**WISCONSIN DEPARTMENT OF
TRANSPORTATION**

**INTERSECTION SAFETY
AUDIT: STH 16/67 AND
CTH Z**

OCONOMOWOC, WI

July 2008

FIGURE 4.1 COLLISION DIAGRAM

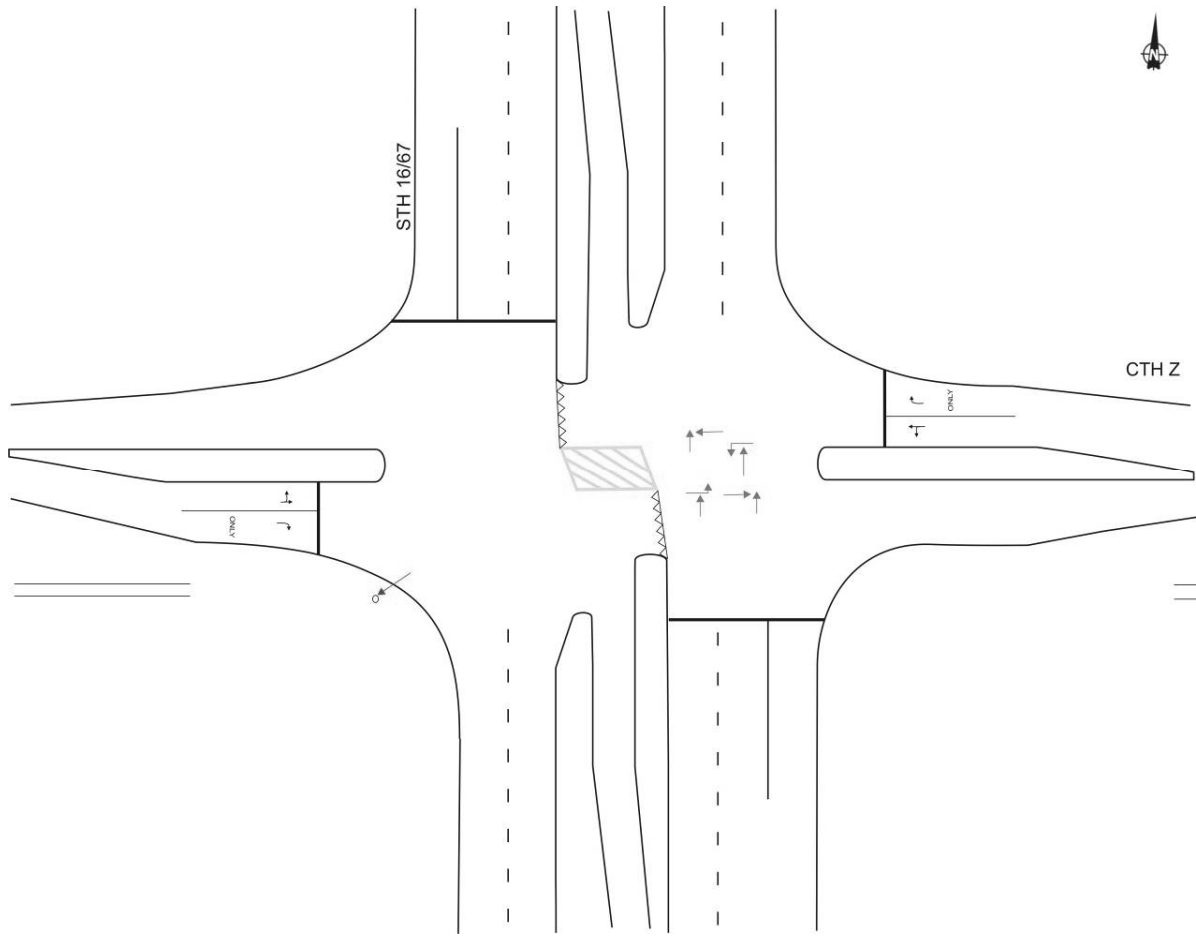
Police collision reports (MV4000) for 2005 through 2007 were reviewed as part of this study. Over these three-years, five collisions were recorded at or near the intersection. As summarized in TABLE 4.1, one fatality and one injury occurred at the intersection. The remainder of the collisions involved property damage only.

A collision diagram illustrating the spatial distribution of the collisions is shown in FIGURE 4.1.

FIGURE 6.1 SAFETY ISSUES

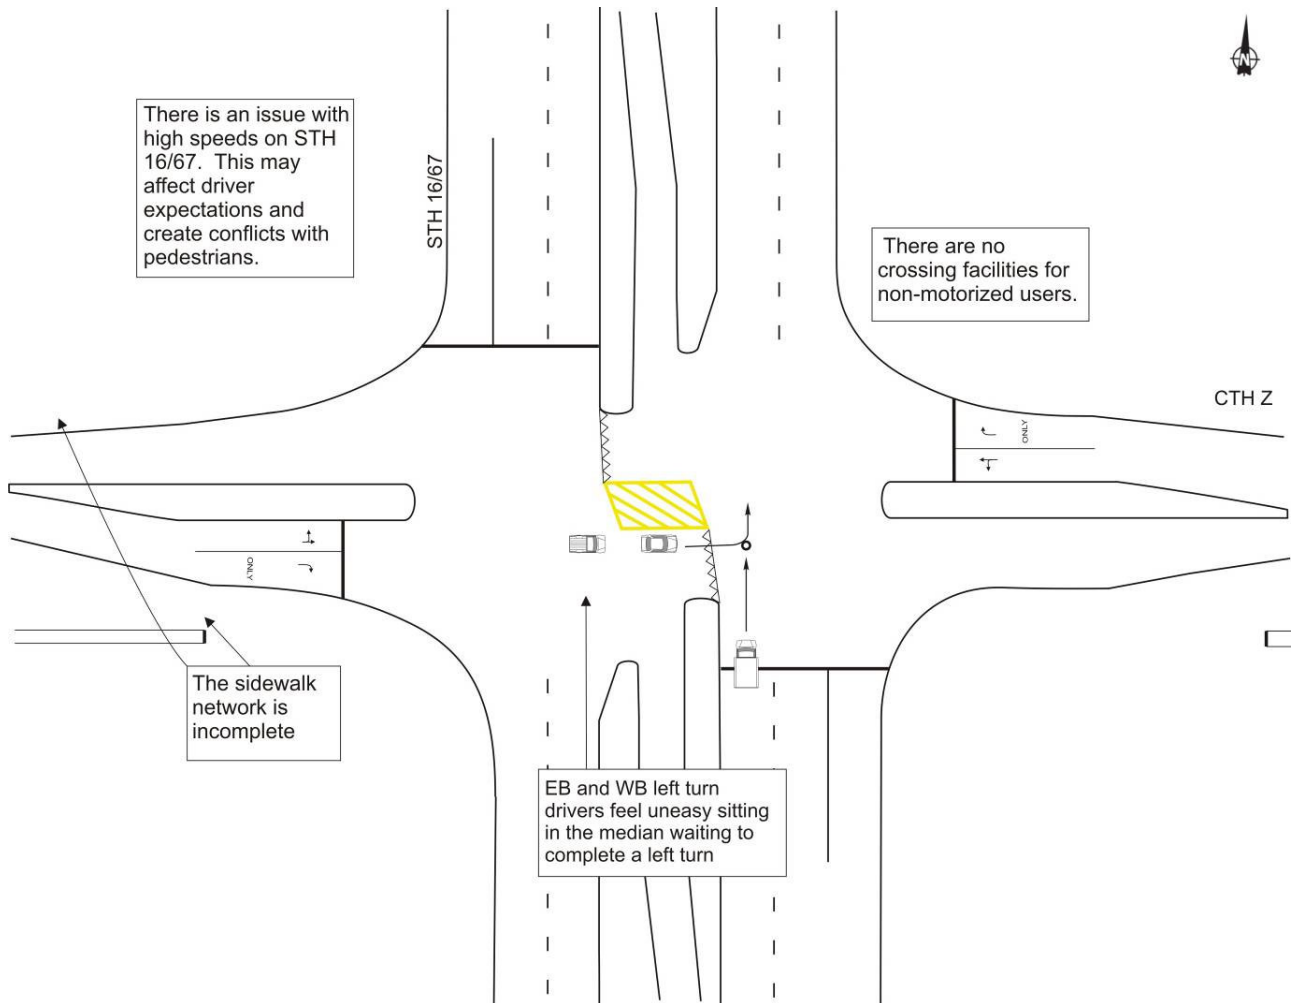
6.1 Issue 1: Non-Motorized Road Users

In September 2008, a new middle school is scheduled to open on the northeast quadrant of the intersection. A YMCA is also scheduled to open in early 2009. The nearby residential subdivisions are expected to generate substantial numbers of younger non-motorized road users. As this is a middle school many of these non-motorized road users are expected to be walking or bicycling across STH 16/67 will be between the ages

11 and 14 years old. There are currently no pedestrian or bicycle facilities at this intersection as it was part along a high-speed bypass. The existing sidewalks adjacent to CTH Z terminate prior to the intersection.

Younger pedestrians are typically more inexperienced and have a high propensity to take risks. These inexperienced pedestrians may choose inadequate gaps as they are not as good at judging approach speeds. In addition, as is shown in the photo on the right, younger road users also will make risky maneuvers as a means to “show off.”

6.2 Issue 2: CTH Z Approaches

There are multiple conflict points associated with making a direct left-turns onto STH 16/67 from CTH Z. This intersection involves an unprotected left-turn across multiple lanes of opposing or crossing traffic. The risk and potential severity of left-turn crashes is aggravated by:

- high speeds on STH 16/67;
- a high proportion of truck traffic (with slower acceleration and braking capabilities) which is the primary truck route around Oconomowoc;
- the presence of young and inexperienced non-motorized road users;
- winter road conditions (contributing to poor acceleration and braking capabilities).

6.3 Issue 3: Speeds on Bypass

The speeds on the bypass appear to be higher than the posted speed limit. Currently the speed limit on the Oconomowoc Bypass is set at 45 mph, but based on the design and the appearance of the roadway the driver expectation of the speed limit seems to be higher. STH 16/67 has the look and feel of a freeway. As a result, drivers were observed travelling through the intersection at high speeds. The 85th percentile speed of 51 mph is likely due to the active presence of law enforcement, from multiple jurisdictions, work this intersection daily.

FIGURE 6.2 INTERSECTION CONFLICT POINTS¹

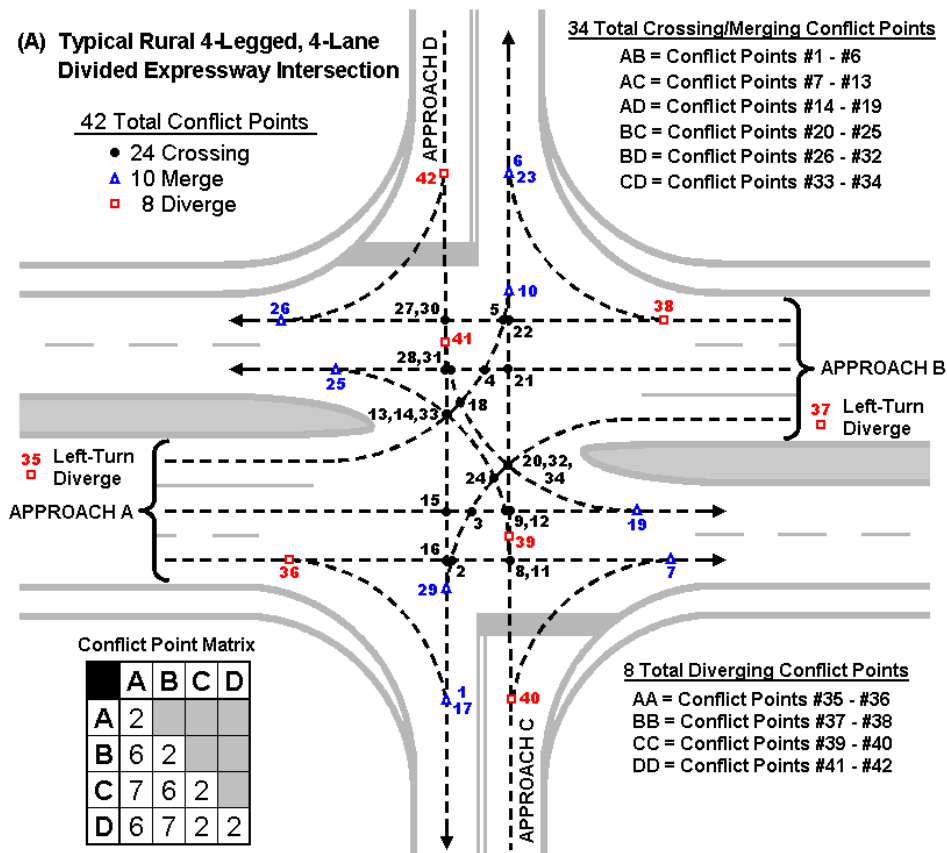
FIGURE 6.1 illustrates a conflict diagram for the typical four-leg the intersection. A total of 42 conflict points exist for this type of intersection configuration. Drivers who misjudge the gaps required to turn left or cross increase the risk of a higher severity rear-end or angle crash with through vehicles traveling at high speeds.

FIGURE 7.1 PROPOSED MITIGATION MEASURES

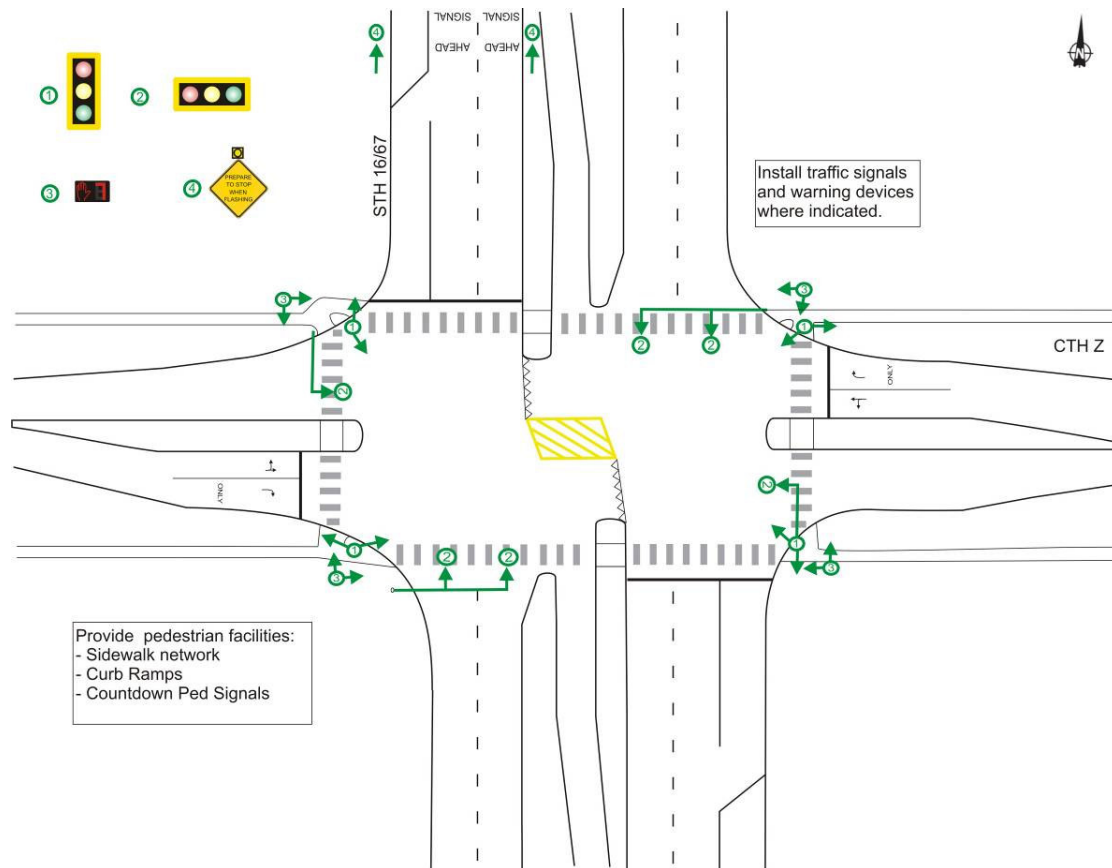
To address the issues that have been discussed in Section 6, mitigation measures have been identified. The proposed measures are summarized in FIGURE 7.1, and discussed below.

Installation of a Traffic Signal

Based on the results of the analyses, it is suggested that WisDOT consider installing a fully operational traffic signal for this intersection. It is expected that pedestrian volumes of school children will exceed 20 pedestrians per hour. This traffic signal will help to provide gaps for pedestrians to cross STH 16/67.

Pedestrian Countdown Signals

Pedestrians (particularly younger pedestrians) may unintentionally enter the crosswalk with an insufficient amount of clearance time remaining. A pedestrian countdown display (*right*) may be added to a pedestrian signal head to accurately inform pedestrians of the time remaining in the pedestrian clearance interval, so that they can complete their crossing before conflicting traffic starts up.

Advance Warning Flasher

In conjunction with a new signal, an advance warning flasher should be considered for the southbound approach of STH 16/67. The advance warning flasher should utilize the message "PREPARE TO STOP WHEN FLASHING." These devices have been found to be extremely effective at locations where drivers are transitioning from a high speed access controlled expressway into an area with at-grade signalized intersections. This advance dilemma zone warning device has been found to reduce traffic fatalities and injuries by 39 percent³ at rural high speed intersections. While some drivers may increase their speeds right when the device starts flashing, the majority of drivers have been found to be more aware of the signal. These devices can be installed either overhead or post mounted. Examples of the two types of mountings are shown below on the following page.

Signal Ahead Pavement Markings

To supplement the advance warning flasher it is suggested that “SIGNAL AHEAD” pavement markings be considered. Warning messages on the pavement have been found to be effective in drawing attention to hazardous situation and are meant to supplement other traffic control devices.

Adult Crossing Guard

Adult crossing guards help to provide gaps for and assist school children cross the street. It is suggested that adult crossing guards be considered for this intersection. If adult crossing guard supervision is utilized, it is suggested that two adult crossing guards be posted at this intersection due to the width and that it is a two-stage crossing.

High Visibility Crosswalks

High visibility crosswalks should be considered for this location. High visibility crosswalks which utilize the ladder or zebra style striping are more visible to approaching drivers.

Sidewalks

Filling in the gaps on the sidewalk network should also be considered to accommodate pedestrians at this intersection. Sidewalks should also be considered along the north side of CTH Z adjacent to the proposed school. Sidewalks will help to define the path which pedestrians are encouraged to take when accessing the school.
